CITY OF LEWISTON
PLANNING BOARD MEETING
Monday, July 28, 2014 – 5:30 P.M.
City Council Chambers – First Floor
Lewiston City Building
27 Pine Street, Lewiston

TO: Planning Board
FROM: David Hediger, City Planner
DATE: July 24, 2014
RE: July 28, 2014 Planning Board Agenda Item IV(a)

TO: Planning Board
FROM: David Hediger, City Planner
DATE: July 24, 2014
RE: July 28, 2014 Planning Board Agenda Item IV(b)

BATES LEWISTON RESPONSE

1 PLANTING PLAN

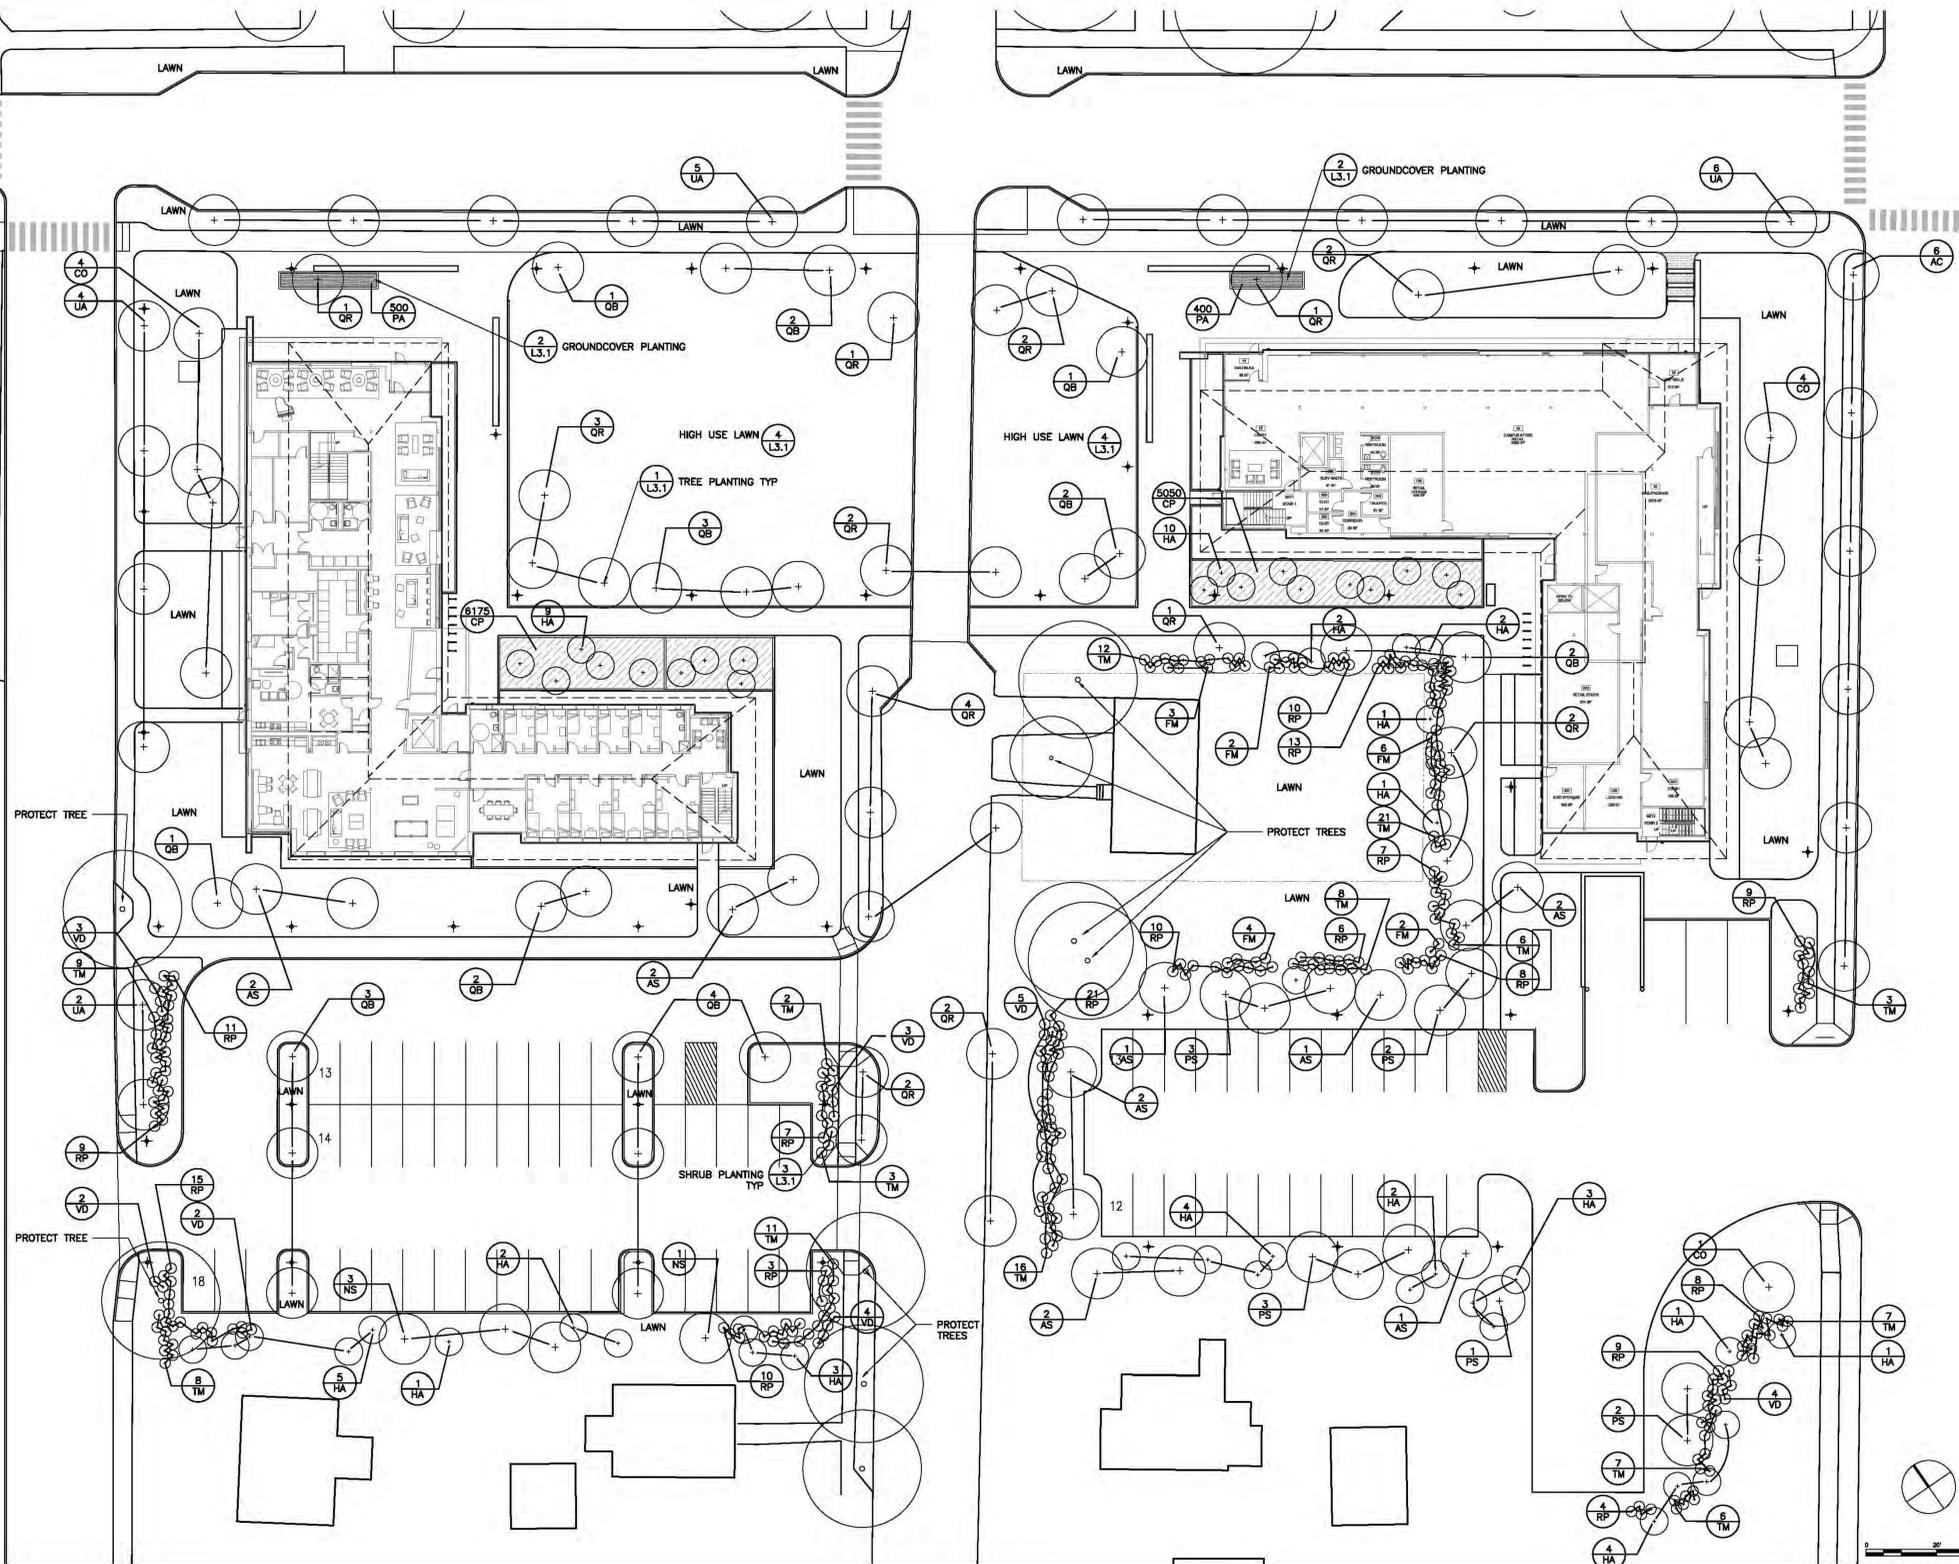
5. Sheet L1.3 – Planting Plan

Four Accolade Elm trees are proposed for the esplanade on Bardwell Street, these trees are being proposed 3-5 feet from the existing watermain. These trees shall be moved back to behind the sidewalk.

Five Northern Red Oak trees are proposed for Franklin Street which will either be on top of the water main or within 3-5 feet of the watermain. These trees shall be moved back to provide separation.

Response: The proposed esplanade on Bardwell Street has been eliminated, the side walk has been relocated and the trees have been moved off

Response: The trees have been relocated off of the watermain.
